City: AUGUSTA Street, Road, Etc.: EIGHT ROD ROAD Plumbing Permit No.: 4-18-80 Date Of Plumbing Permit: 23014 EP

Owner Of Property: Gabriel Dostie Tel. No.: 622-5284 Name Of Applicant Owner's Agent: Tel. No.:
 Address: RFD 3, Box 19 Street: State: Zip Code: Town: State: Zip Code:

APPLICATION FOR SUBSURFACE WASTEWATER DISPOSAL PERMIT
(For systems disposing of less than 2000 gallons per day)

Subject: Variance to the Maine Plumbing Code, Part II, Gabriel Dostie property,
Lot #5, Dostie Bros. Subdivision, Eight Rod Road, Augusta

SEWAGE DISPOSAL BED DETAILS

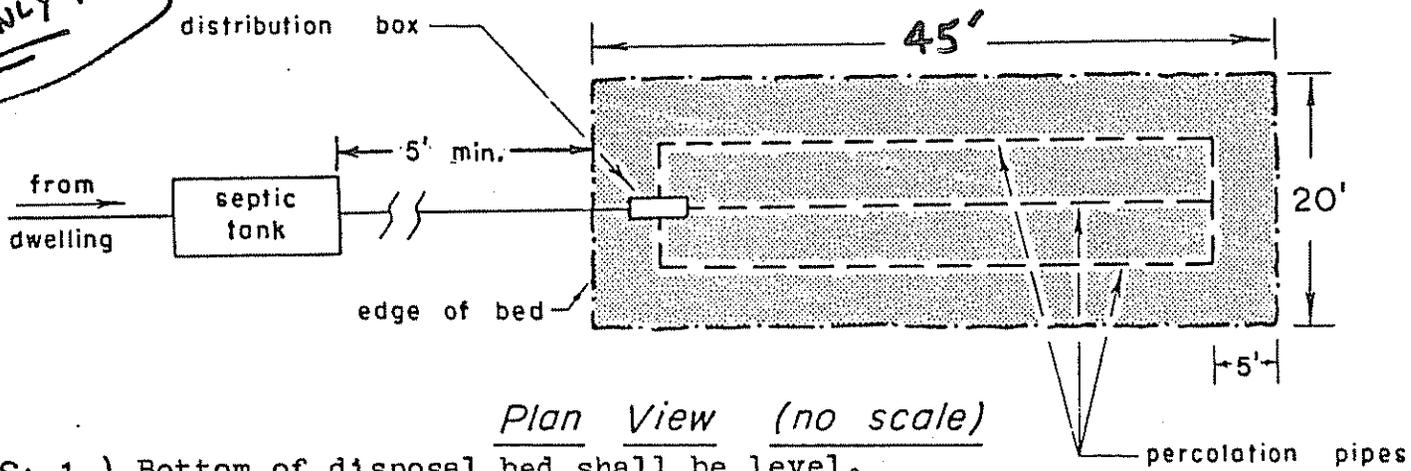
At least 0 inches and 24 inches of fill shall be applied on the uphill and downhill sides of the disposal field, respectively. The fill shall be of a texture similar to the original soil and will provide a 24 inch separation between the bottom of the disposal bed and the seasonal high water table and impervious layer. The fill must be extended in all directions as required by Chapter 9 of the Maine Plumbing Code, Part II.

- * NOTES:
- 1.) Bottom of disposal bed shall be level.
 - 2.) 0 inches of fill is required at uphill end of bed.
 - 3.) Texture of backfill and perimeter fill shall be similar to original soil.
 - 4.) If pump is used, the bed should be vented (see Sec. 8.2, Code, II).
 - 5.) Refer to Sections 8.4, 9.3, Table 6-1, and Appendix of the Maine Plumbing Code, Part II, for further details regarding installation requirements.
